MATERIAL	UNLESS OTHERWISE SPECIFIED	DRAFT	C. BOYER	DATE	8-3-82	TITLE	65W POWER SUPPLY
FINISH	TOLERANCES XX = \pm 0.10 XXX = \pm 0.05 ANGLES = 21° HOLE DIA TOLERANCES .014 - .250 = \pm .005 .251 - .750 = \pm .008 .751 - UP = \pm .015	CHECK		DATE			
	DIMENSIONS ARE IN INCHES AND APPLY AFTER PLATING	DESIGN	S. MOHR	DATE	10-29-82		
	DO NOT SCALE THIS DRAWING	APPRO		DATE			
		APPRO		DATE			
						PROJ. 371	SIZE D
						DWG. NO. 0000164	SCALE SHEET OF 1
						NONE	1

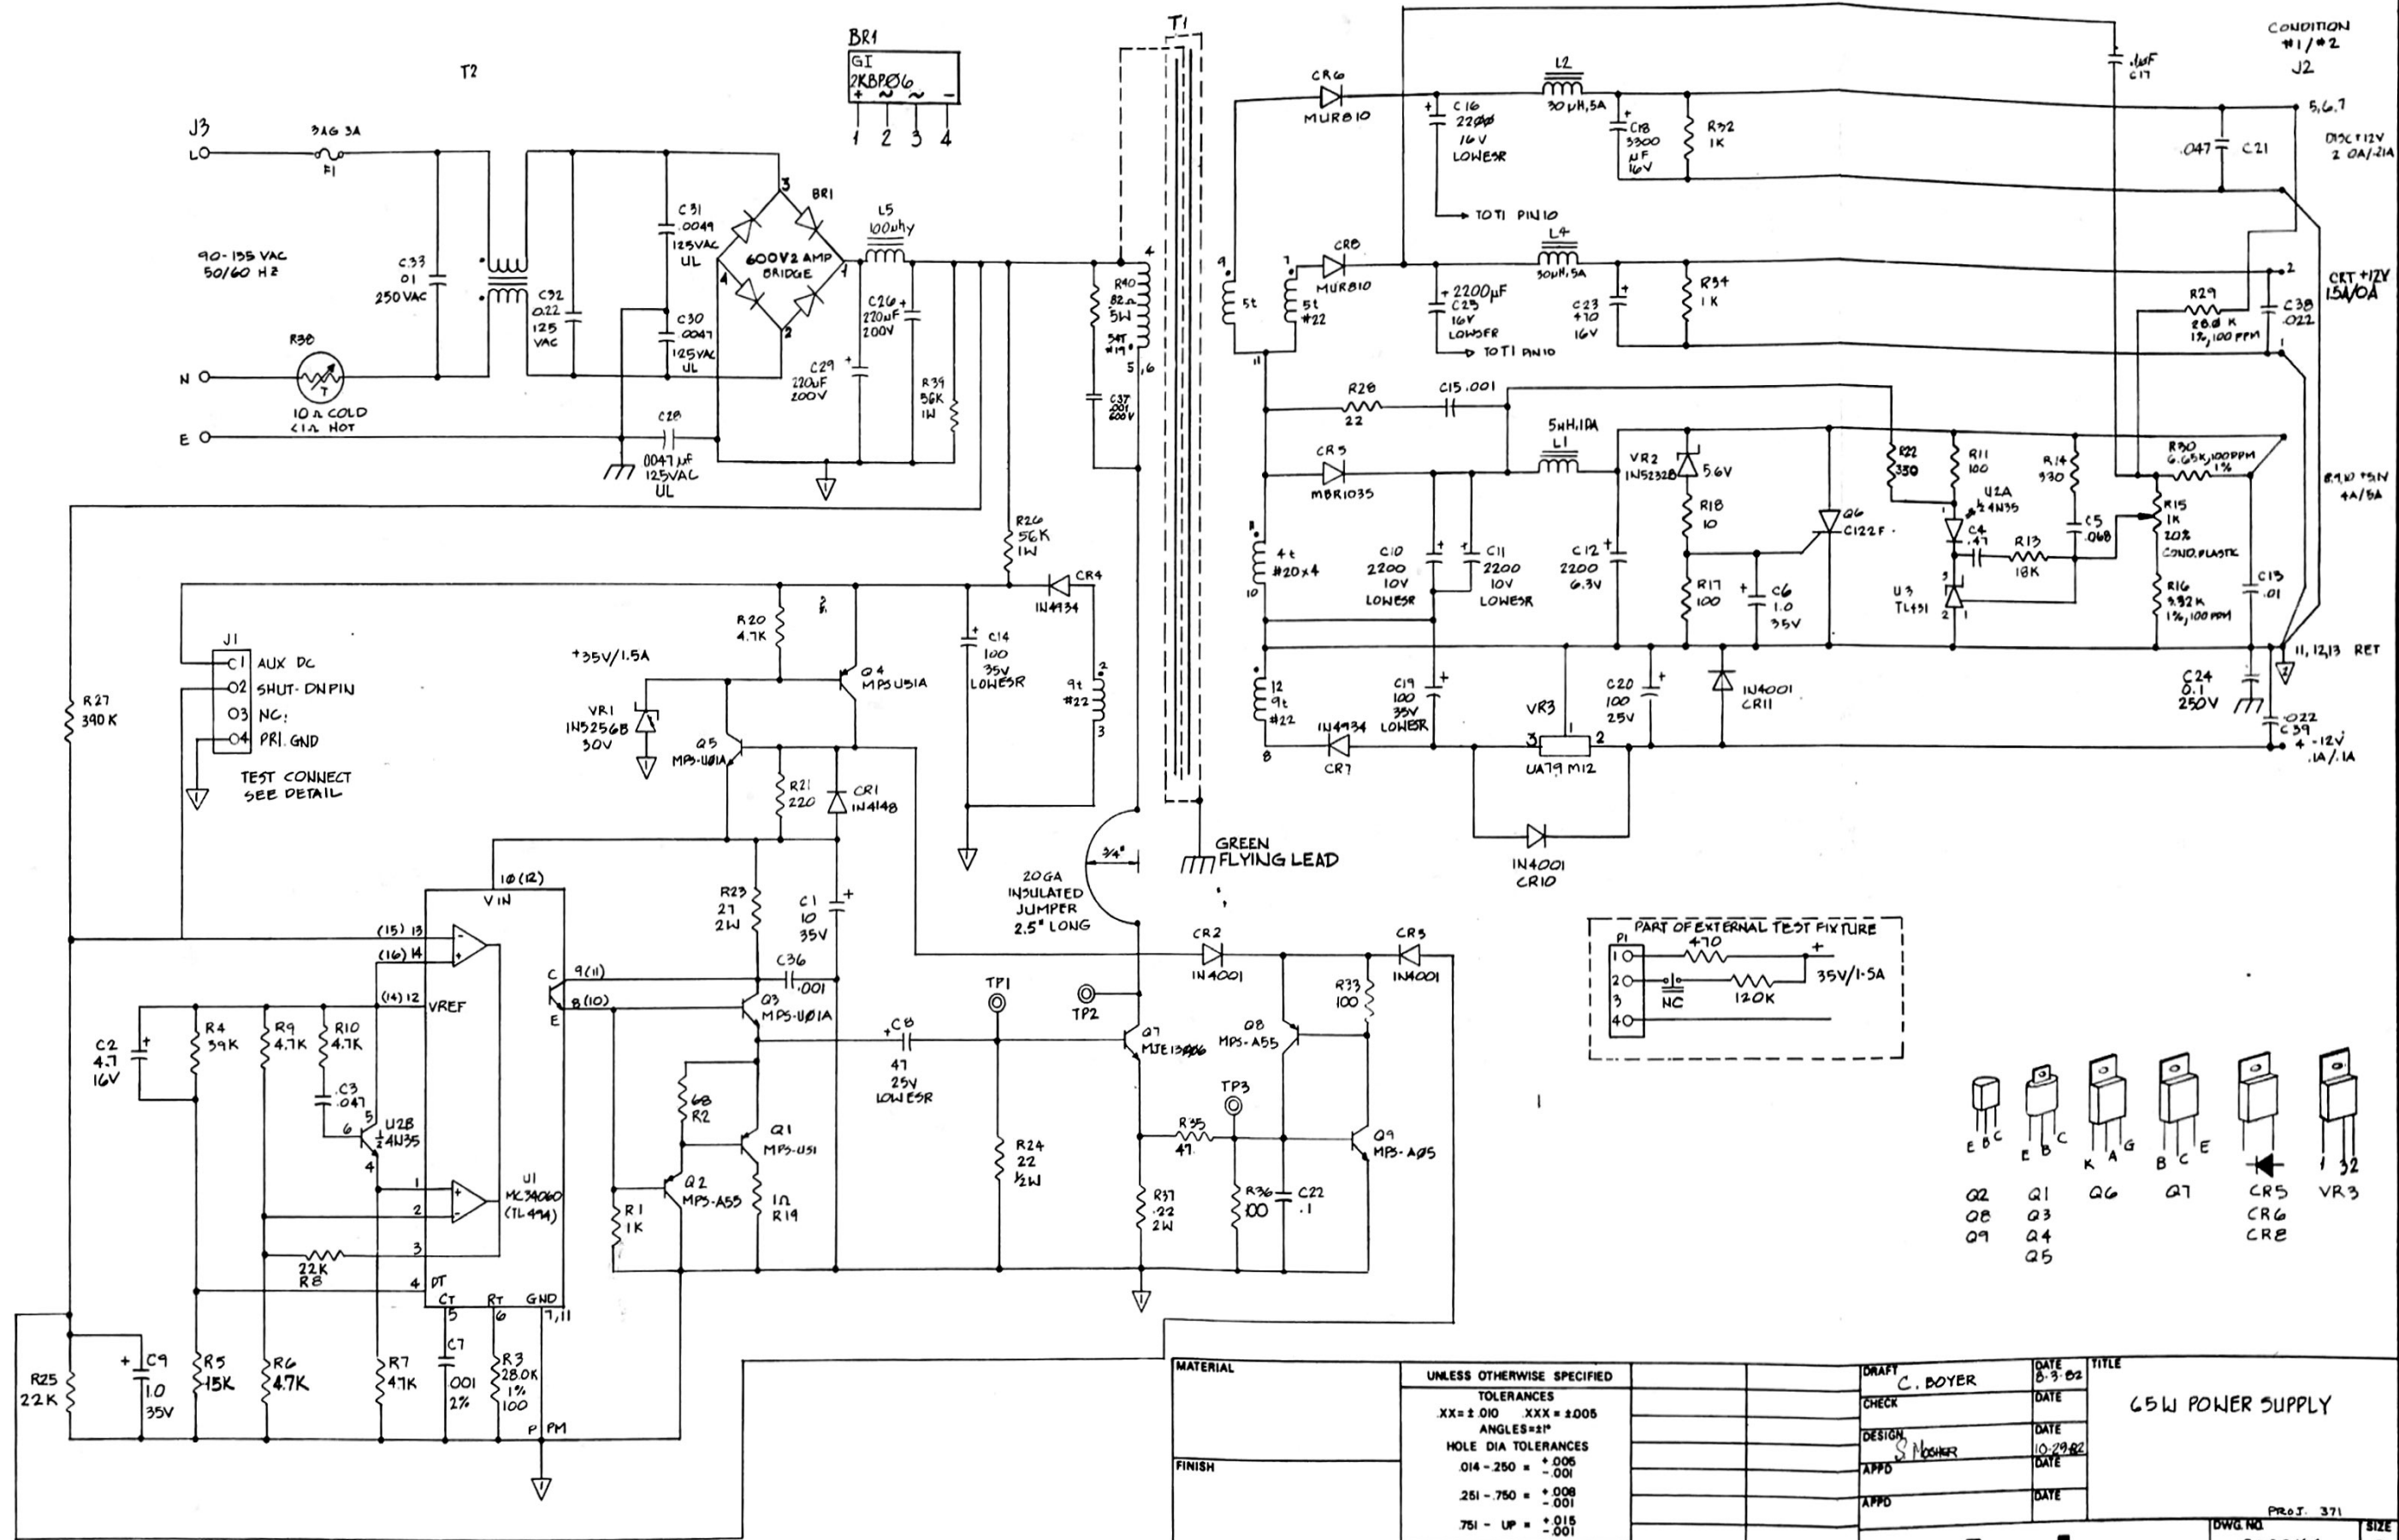
REV	DESCRIPTION	DATE	APPROVED	ZONE	REV	DESCRIPTION	DATE	APPROVED
D	REMOVED C27 & CR9 / MOVED C37 / Q R40 82 Ω WAS 6.8K / ADDED TRACE FROM R29 TO PIN 3,6,7	12-27-82			A	R22 330WAS 100K / DELETED R12	10-27-82	
					B	C17, 10F WAS 0.10US TO C25	10-28-82	
					C	MODIFIED EXTERNAL TEST FIXTURE, ADDED C37 1R3B, 10.2 COLD WAS 10.2 COLD TCO 1332	11-23-82
